ADDENDUM  
NO. 02

**June 20, 2025**

**Edwardsburg Public Schools – US-12 Access Drive Project**  
**27157 US-12**  
**Edwardsburg, MI 49112**

# Edwardsburg Primary & Intermediate U.S. 12 Access Drive

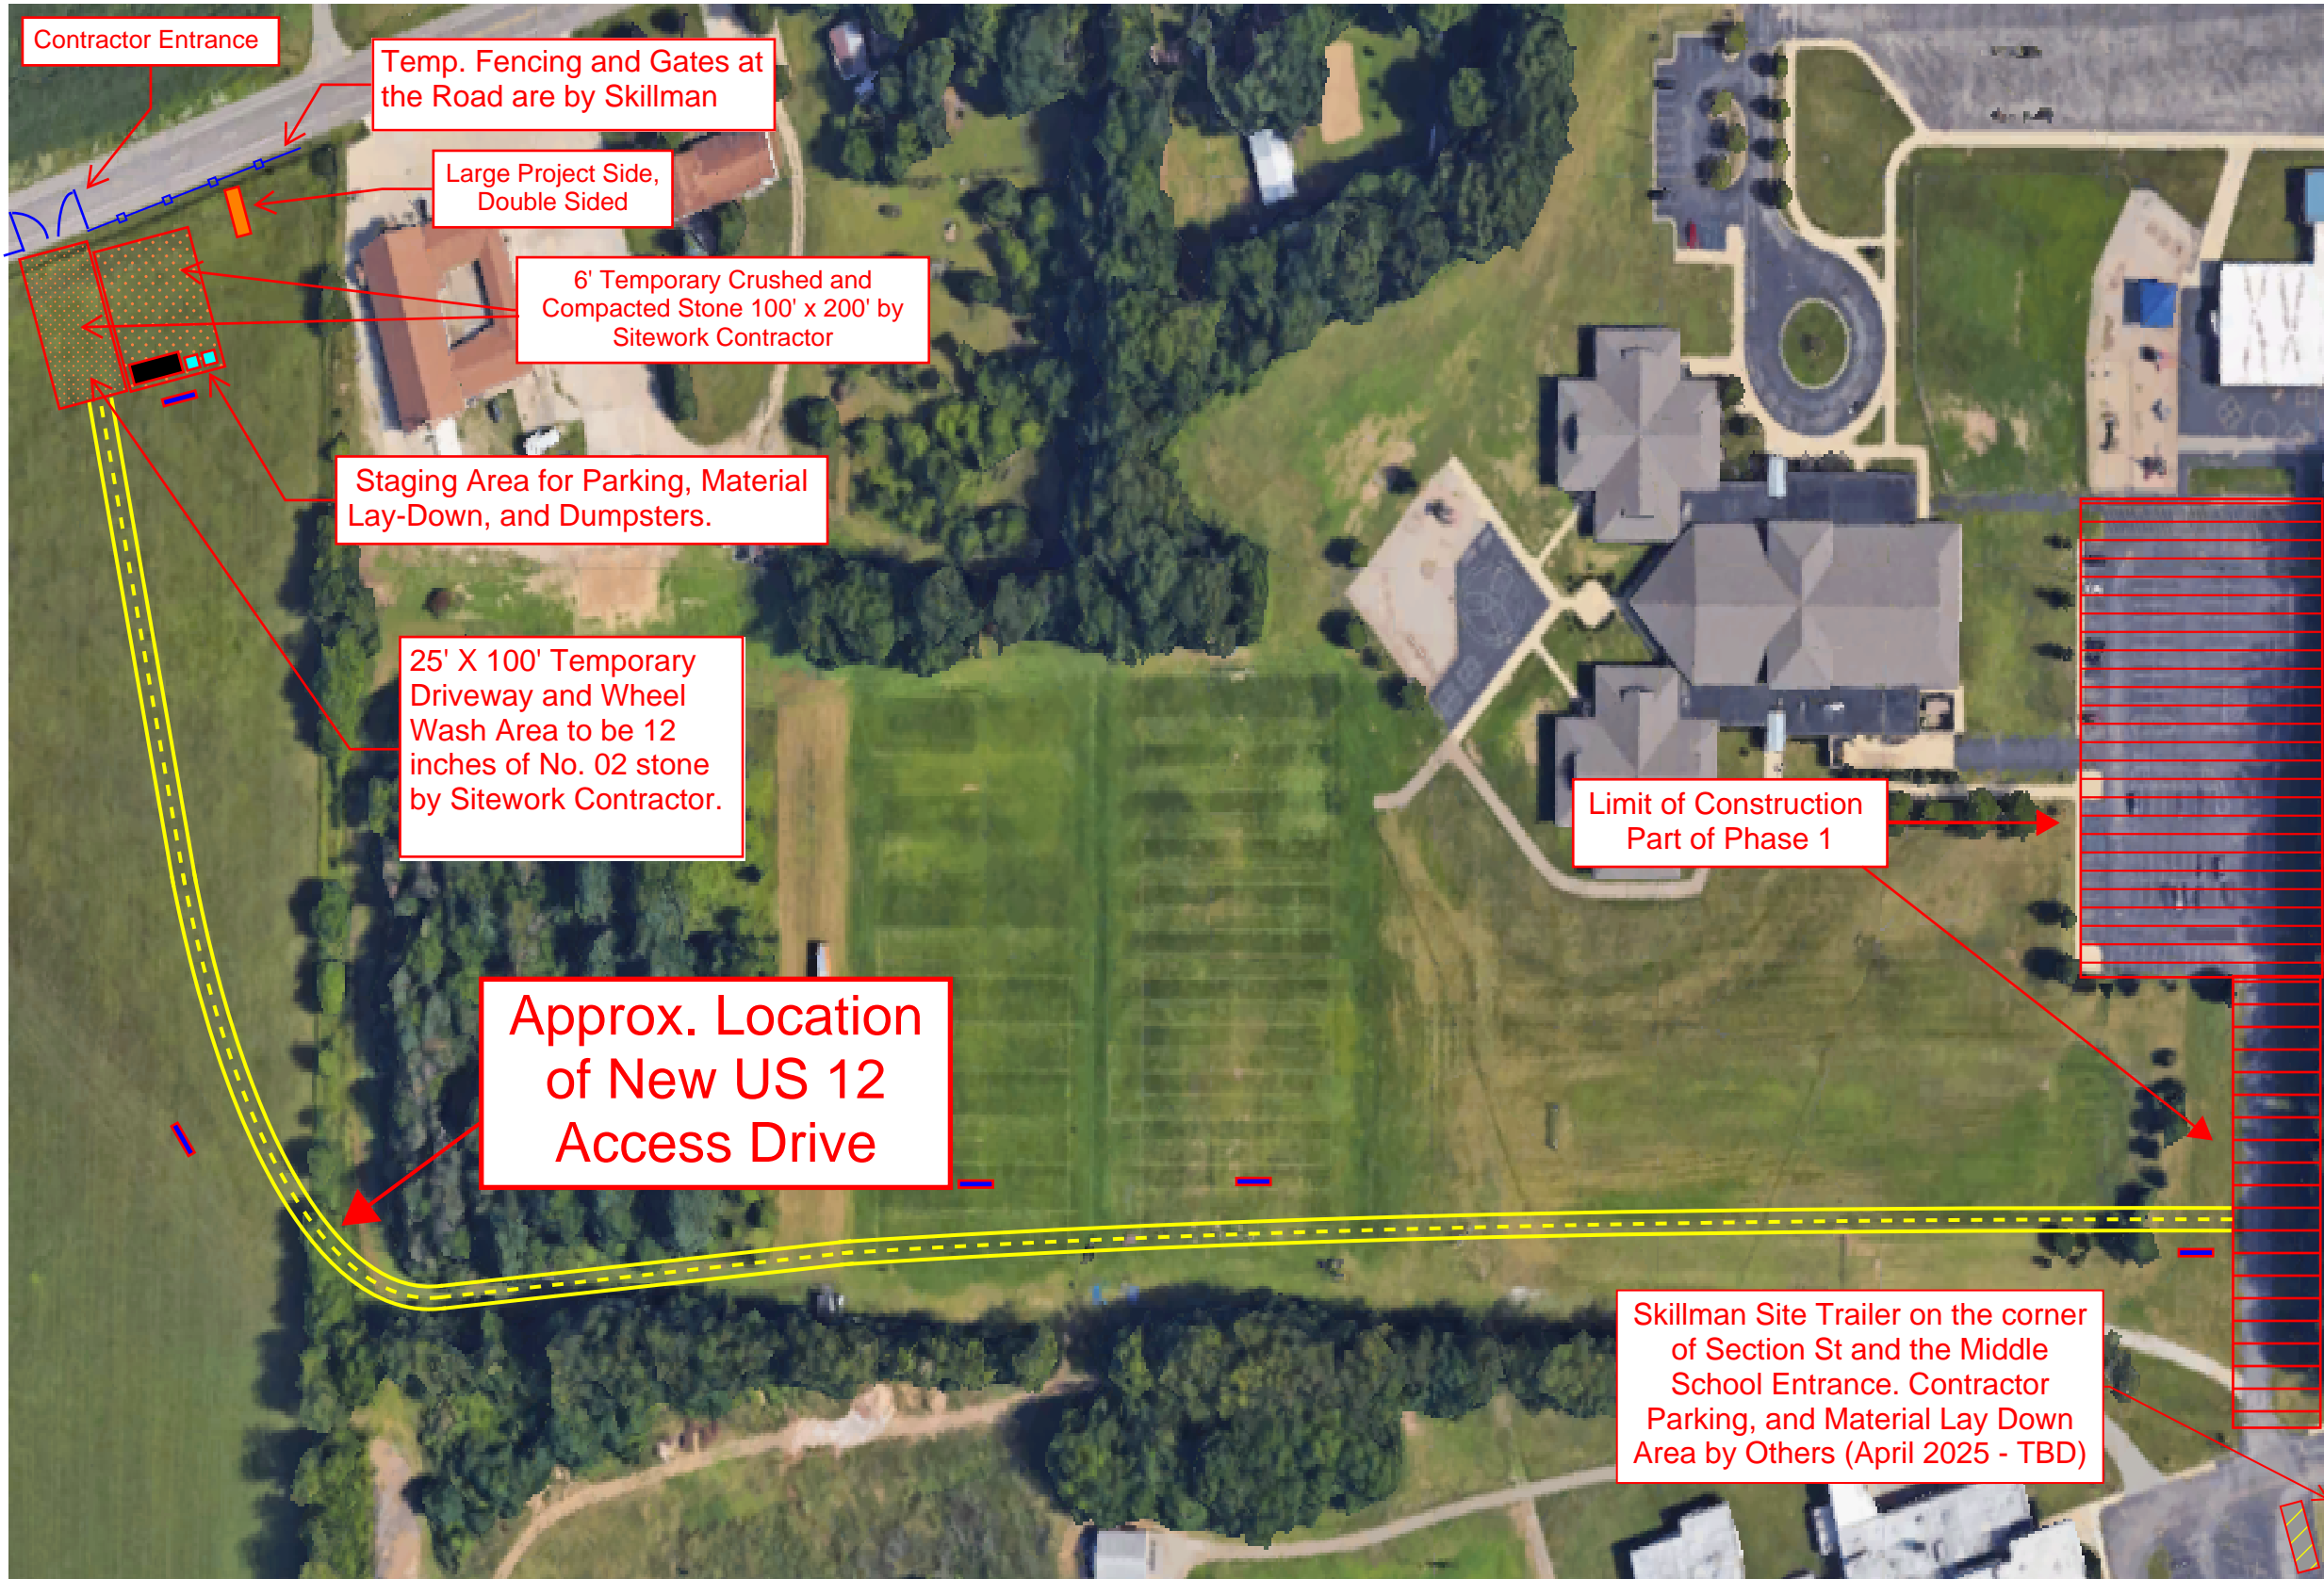
1. See Site Logistics Plan attached.
